Access Compliance Report Public Rights-of-Way (Curb Ramps)

Main Street: FAIRHAVEN_AVE Cross Street: HEWES_AVE Location: NW

ADA ID: RPRK211006181241 Ramp Type: Type 1 - Perpendicular Diagonal Initial Pass/Fail: Pass Overall Compliance: No Severity Score: 10

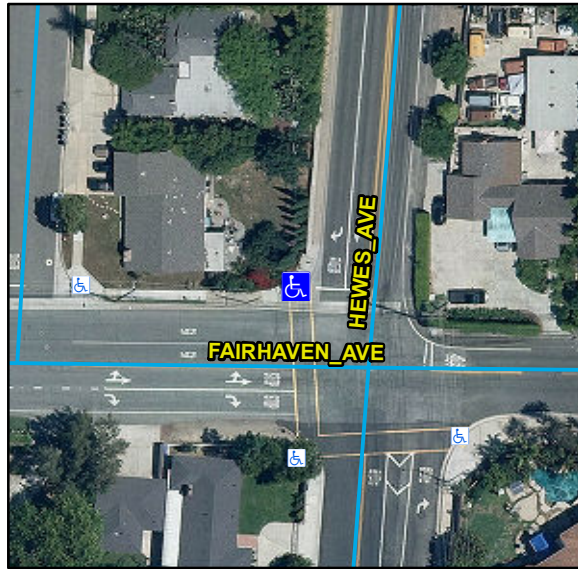
Remove & Replace Curb Ramp With Two New Directional Ramps or Equivalent. Remove & Replace Gutter.

R304.2.2, R304.2.1, R304.2.2-Perp, R304.3.2-Para, R304.5.3, STD 1115
